SINCLAIR hille architects

Addendum #3

Project Name:	Concordia STEM Seward, NE
Project No.:	16022-05
Date Issued:	May 11, 2018
Bid Date:	Thursday, May 17, 2018

Bench Area of 30 x 10 GH / Floor plan

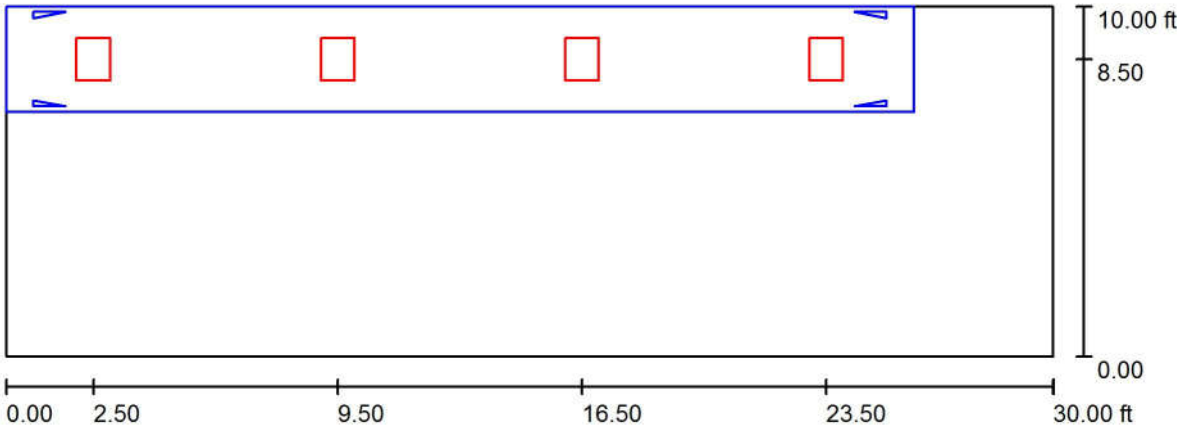
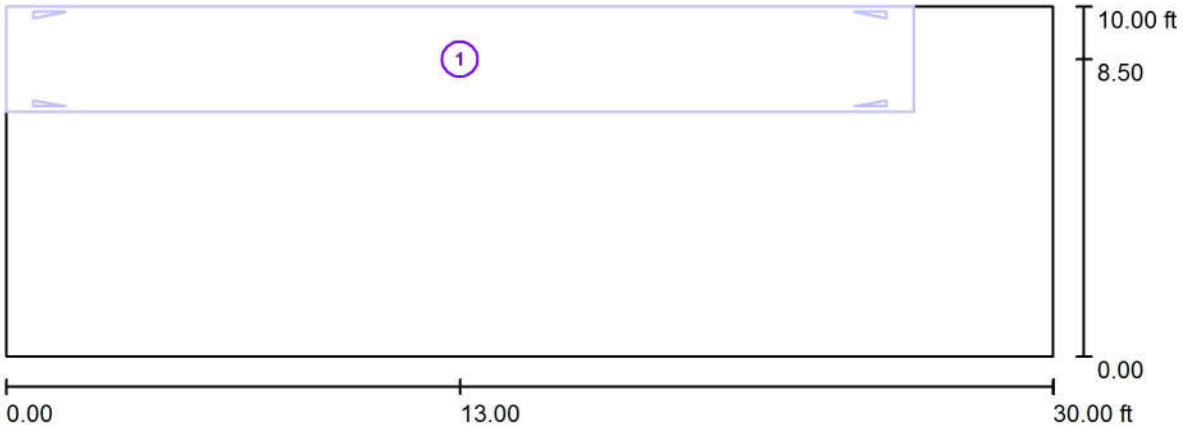
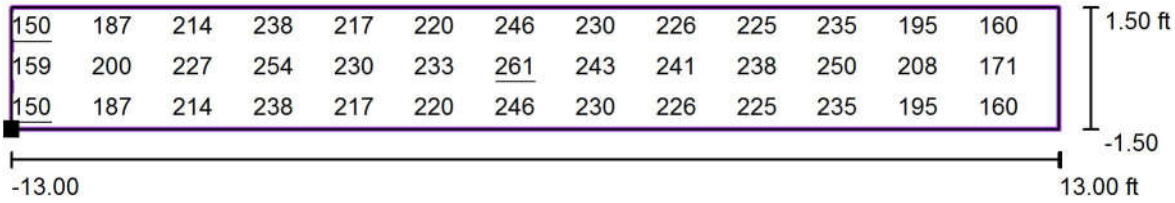
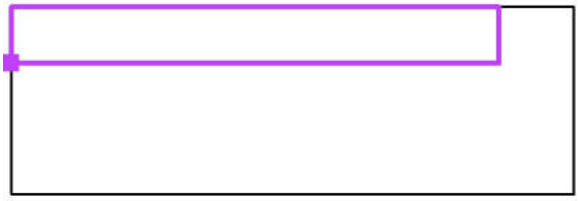
Question: *In the specification it references growth lights except there is no specification clarifying what specific lights are required. Are these to be included with the greenhouse assembly?*

Response: We had been working with Amy Bentz with Nexus Greenhouse Systems and at the time the drawings were released, we had not yet received any information specific to the growth lights. The "greenhouse package" should include the growth lights as part of their package. We have attached to this addendum the lighting information for the growth lights that was forwarded to us by Amy.

A1 INTERIOR ELEVATION

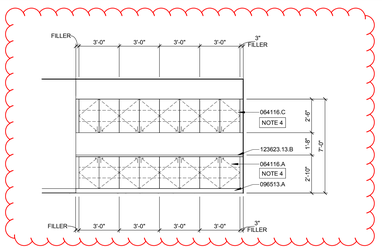
- Detail D7; Locks have been graphically added to the cabinets.
- Detail A7; Locks have been graphically added to the cabinets.
- Detail A1; Locks have been graphically added to the cabinets and Sheet Note 4 has been placed on the elevation.
- Detail G16; Locks have been graphically added to the cabinets and Sheet Note 4 has been placed on the elevation.
- Detail G13; Locks have been graphically added to the cabinets and Sheet Note 4 has been placed on the elevation.

1 Lower Level Mechanical Utilities Piping Plan - Area A.1
1/4" = 1'-0"

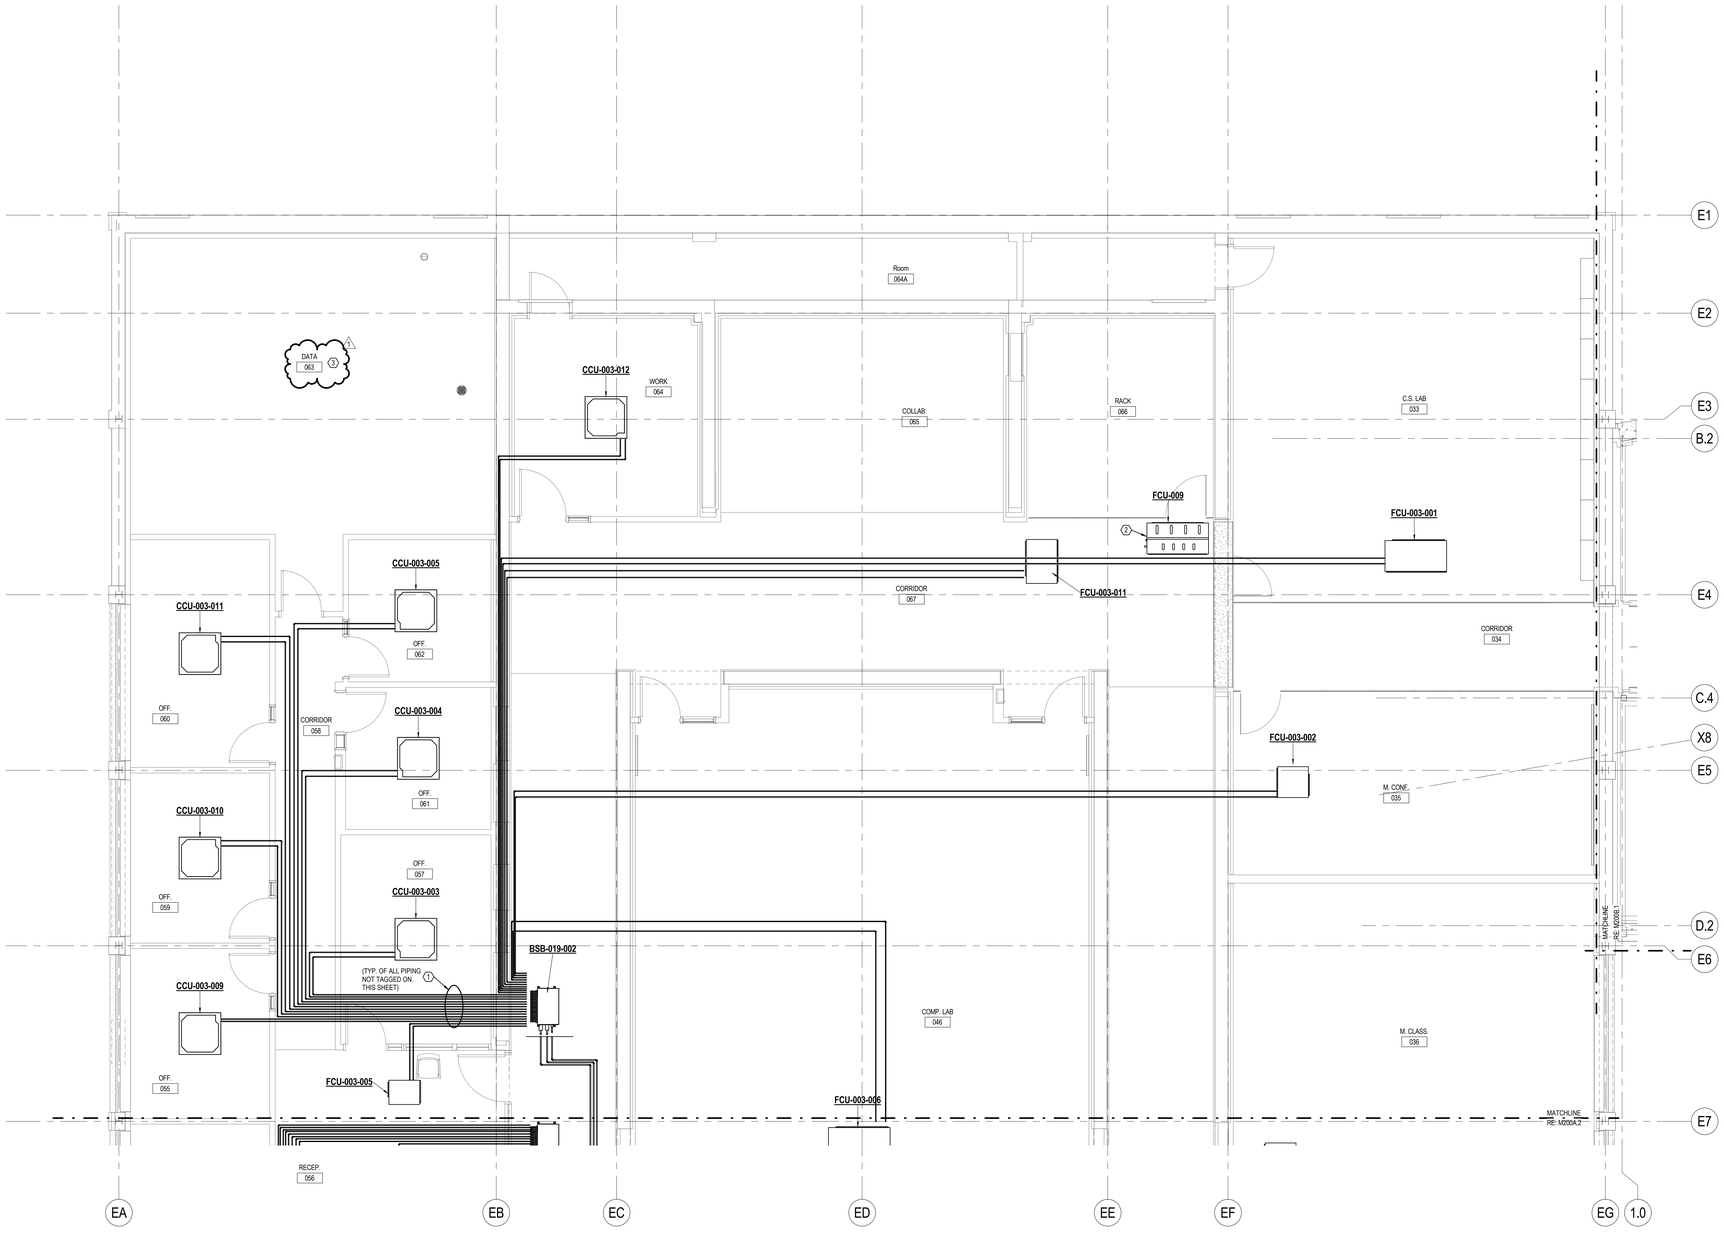
ADD 3-8. Drawing M200A.1. Added keynote to data center to clarify refrigerant pipe routing requirements between rooftop condensers and data center in-row cooling equipment.

1 Roof Mechanical Utilities Piping Plan - Area A.1
1/4" = 1'-0"

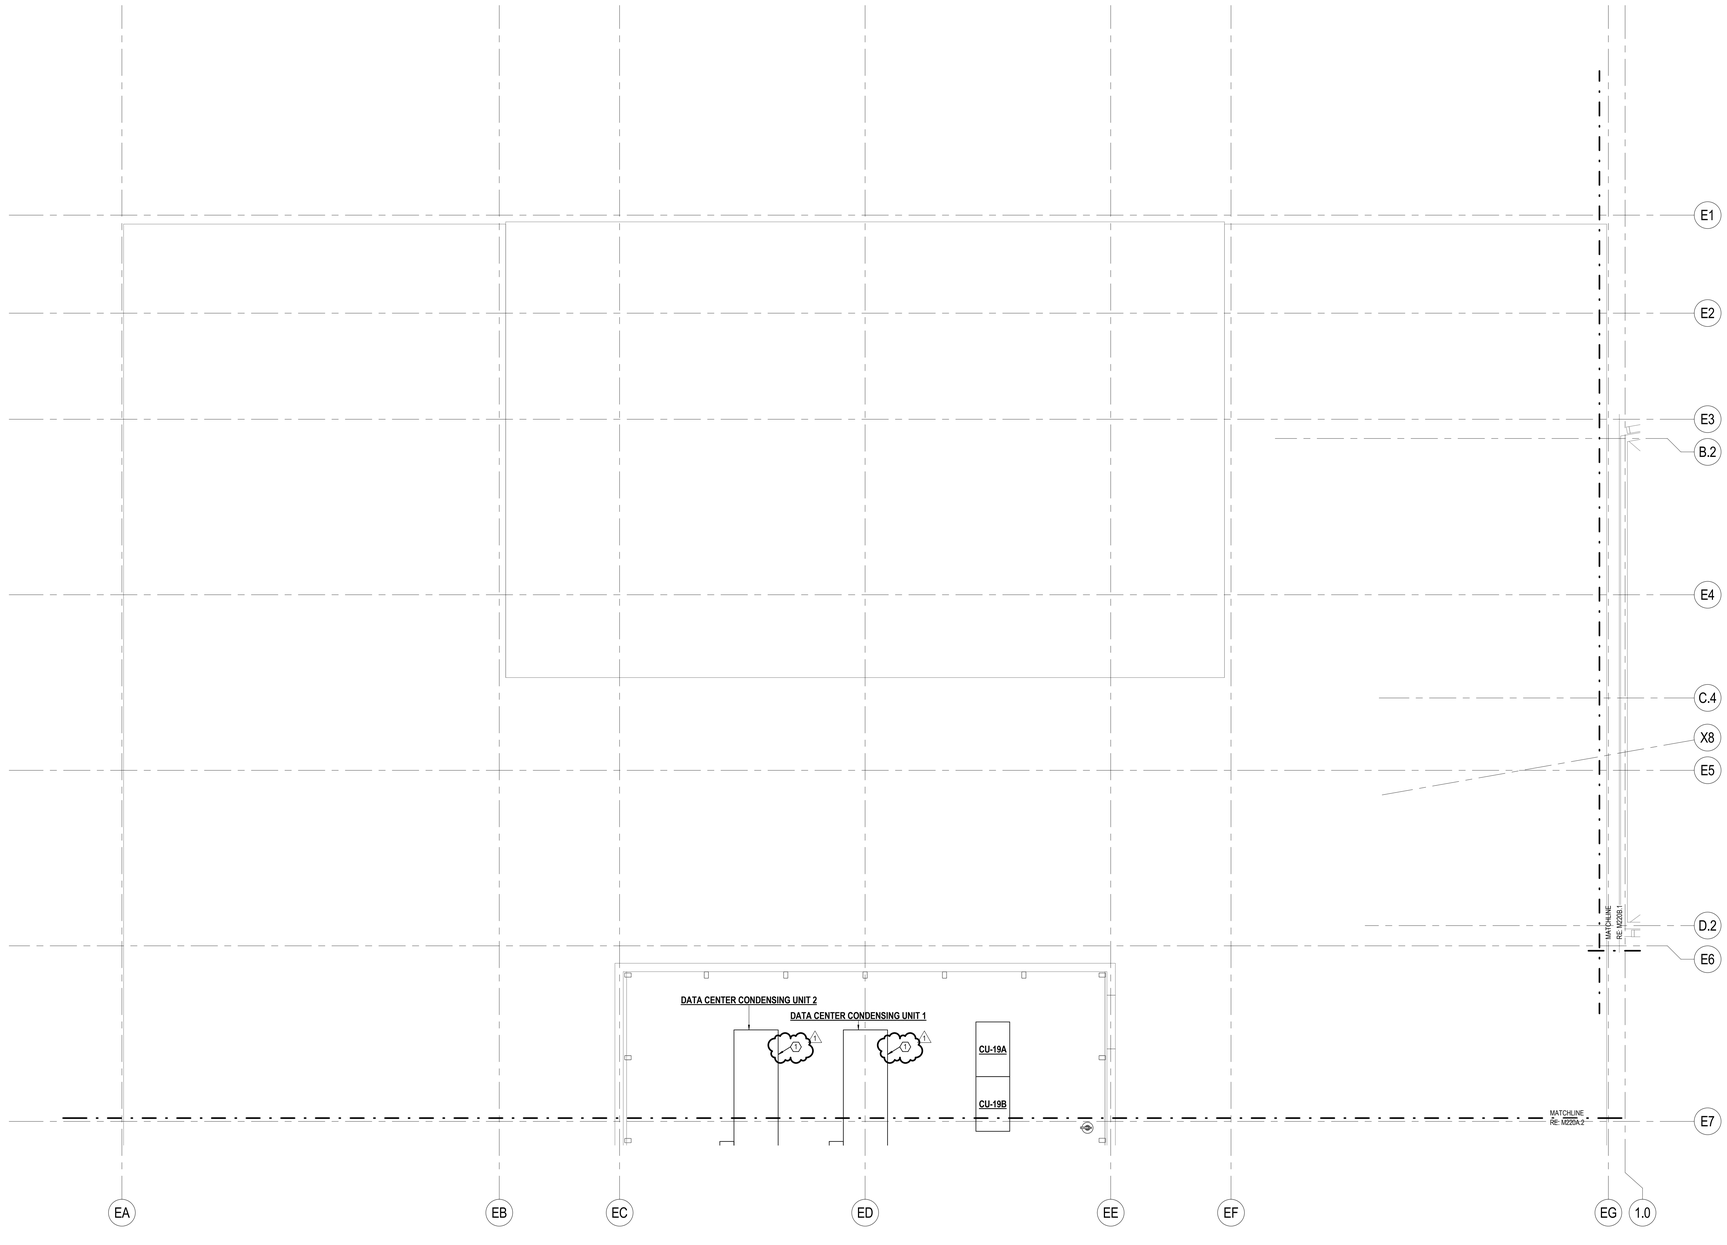
ADD 3-9. Drawing M220A.1. Added keynote to data center rooftop condensing units to clarify refrigerant pipe routing requirements between rooftop condensers and data center in-row cooling equipment.

1 Roof Mechanical Utilities Piping Plan - Area A.2
1/4" = 1'-0"

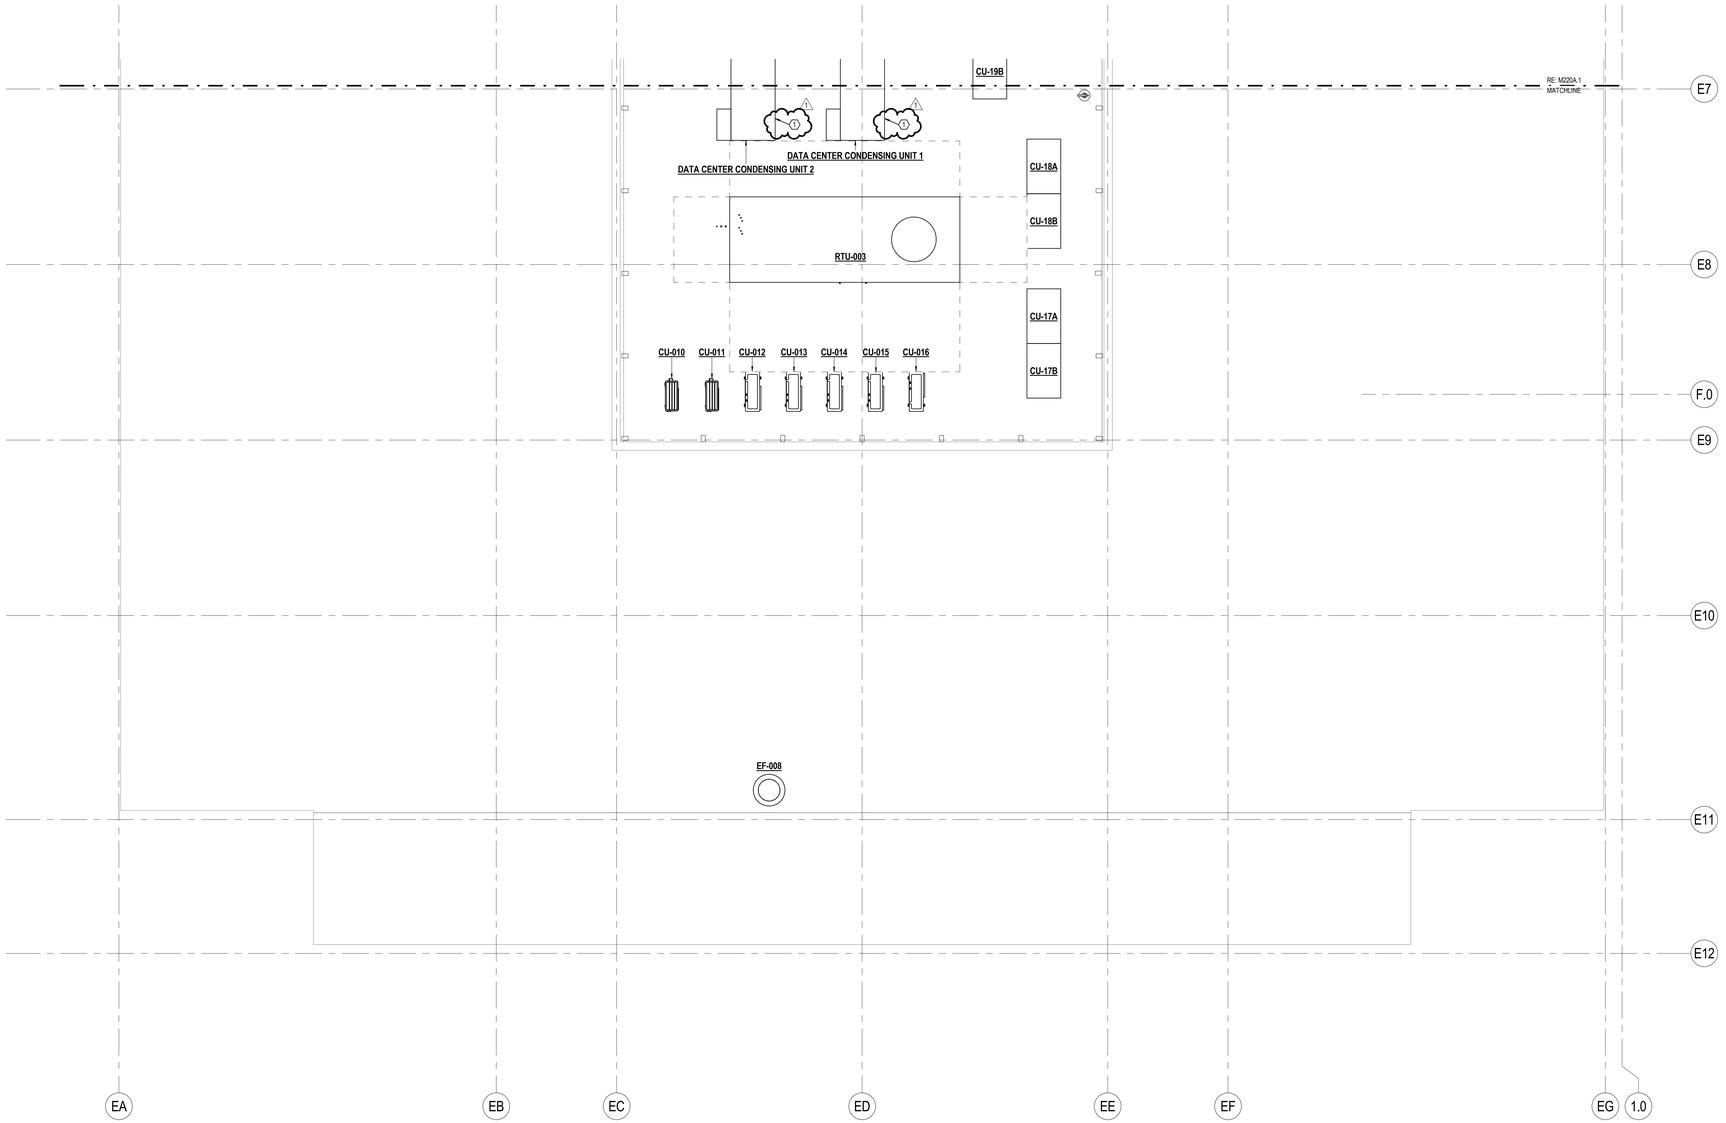
ADD 3-10. Drawing M220A.2. Added keynote to data center rooftop condensing units to clarify refrigerant pipe routing requirements between rooftop condensers and data center in-row cooling equipment.

1 Main Level Plumbing Waste & Vent – Area A.2
1/4" = 1'-0"

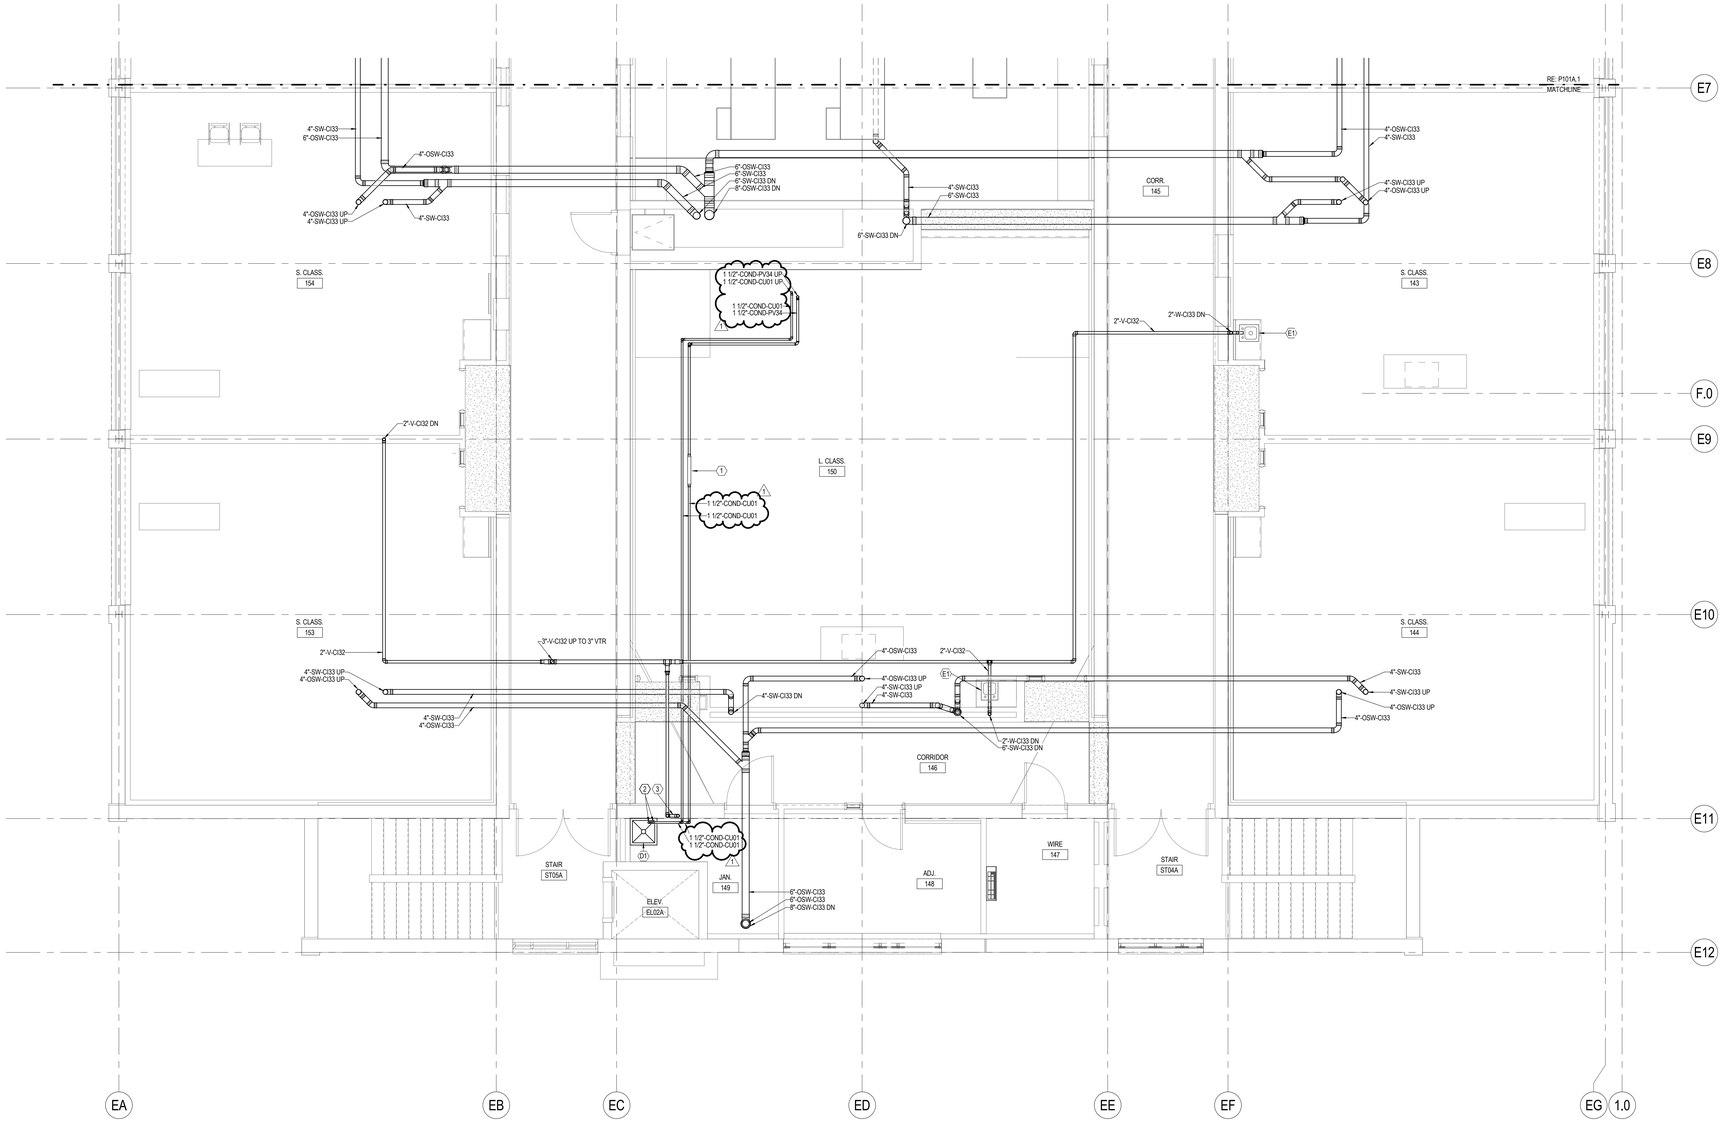
ADD 3-17. Drawing P101A.2. All condensate drain pipe tags updated from “CD” to “COND”.
